<b>SB Number:</b>	<b>SB 2GR-025</b>	<b>Creation Date: 18/02/2009</b>
<b>Subject:</b>	<b><i>The pulley's scanner have been changed for efficiency improvement</i></b>	
<b>Model:</b>	<b>KM-3050/4050/5050, KM-C2520/3225/3232/2525E/3232E/4035E</b>

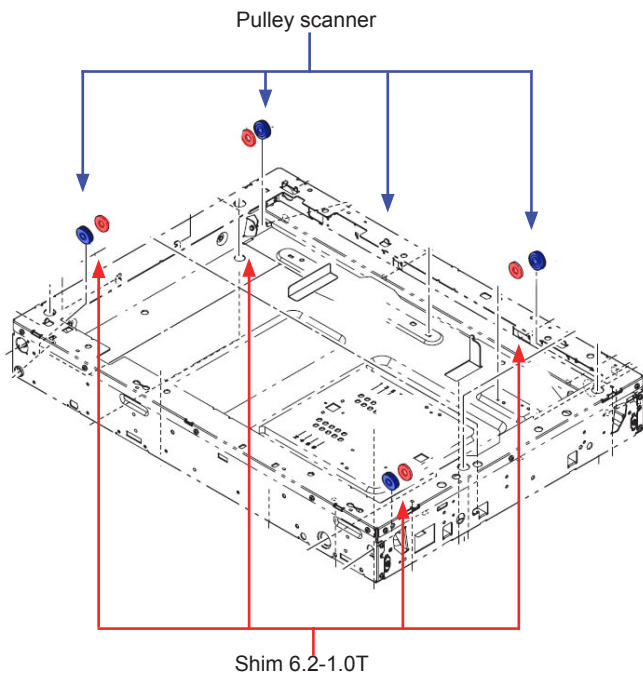
<b>Contents of changes</b>	<p>To improve efficiency, the same type of pulley scanner used at the scanner main frame and mirror frame B has been replaced with 2 different types as followed:</p> <ul style="list-style-type: none"> <li>Pulley scanner 302GR17820 (4 pieces) at the scanner main has been replaced with pulley scanner 302H717160 (4 pieces) and shim 6.2-1.0T (4 pieces) has been discontinued.</li> <li>Pulley scanner 302GR17820 (4 pieces) at mirror frame B has been replaced with pulley scanner 302H717370 (4 pieces).</li> </ul>
----------------------------	---

**New condition at the scanner main frame;** Pulley scanner 302GR17820 has been replaced with pulley scanner 302H717160 and shim 6.2-1.0T has been discontinued.

**New condition at the mirror frame B;** Pulley scanner 302GR17820 has been replaced with pulley scanner 302H717370.

<b>Classification</b>	<input type="checkbox"/> Entire stock rework <input type="checkbox"/> In-field modification at next visit <input type="checkbox"/> In-field modification by case <input checked="" type="checkbox"/> No modification necessary
<b>Field measure</b>	When replacing a pulley scanner, be aware that the types used for the mirror frame B and the scanner main frame have a different shape.
